Appendix Q: Public Involvement

**Connect 378 Public Information
Meeting Materials – July 20, 2023**

CONNECT 378

Safety - Mobility - Community

Alternative 1

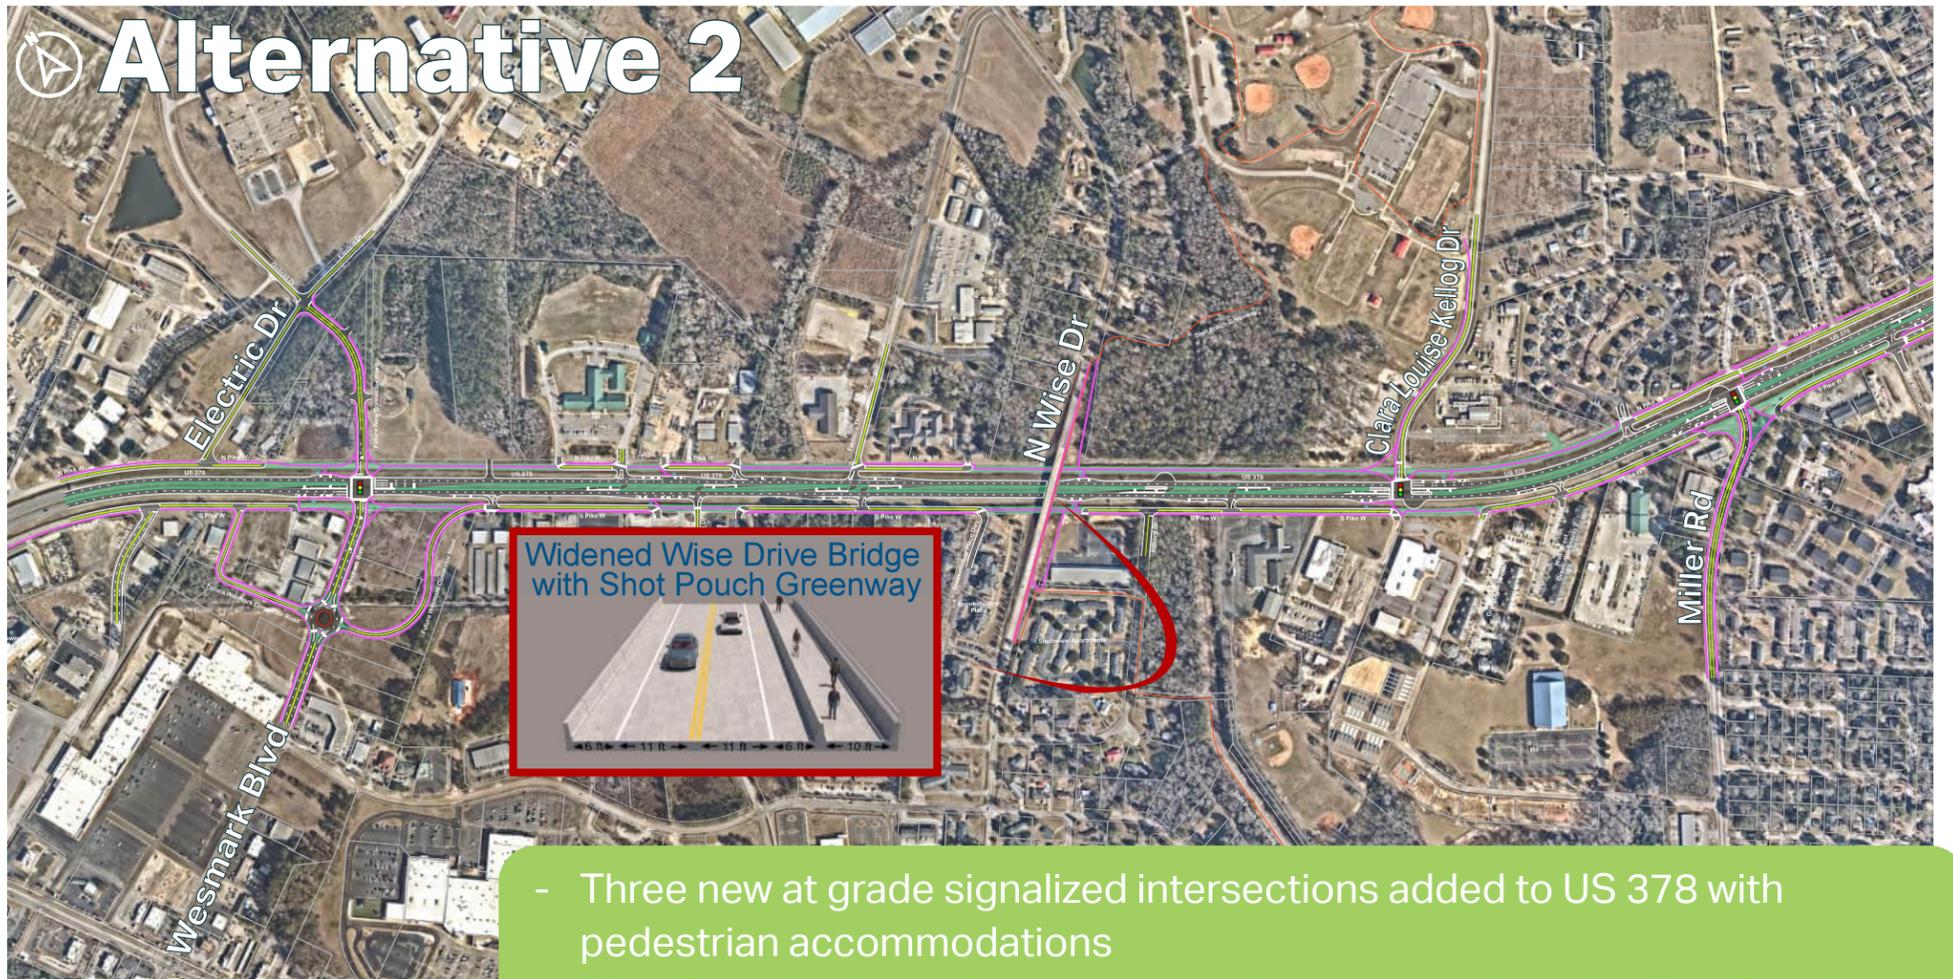
Alternative one seems to allow for smooth flow of both traffic and pedestrians. It offers a way to cross under 378 about halfway down. The other alternatives change the dynamic of 378 Hwy's actual intention: as a freeway. However, what will keep pedestrians from crossing where they currently do? Very tall fences??

Alternative 2

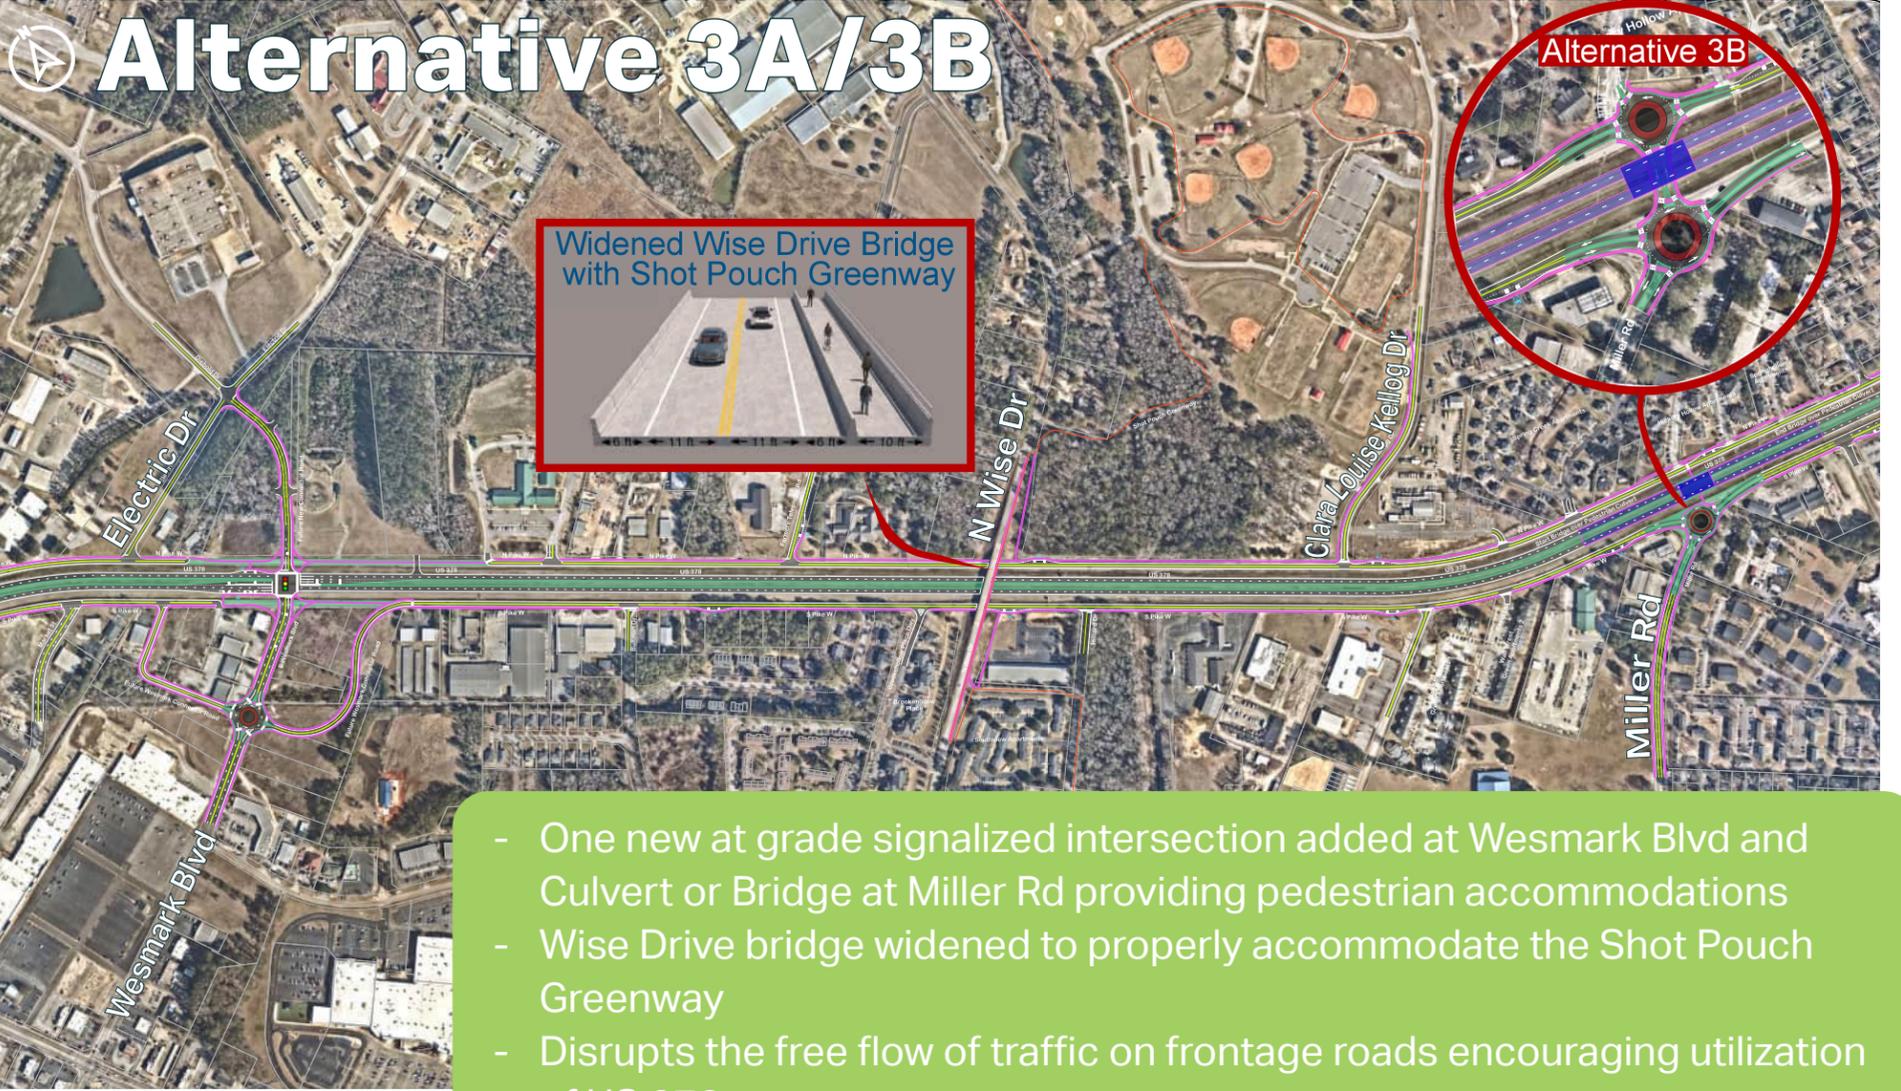
Roundabouts shouldn't be added to 378 all that will do is slow down traffic and cause problems. Just build a walking bridge above 378 for foot traffic in a couple of spots. It would be cheaper than messing with the road
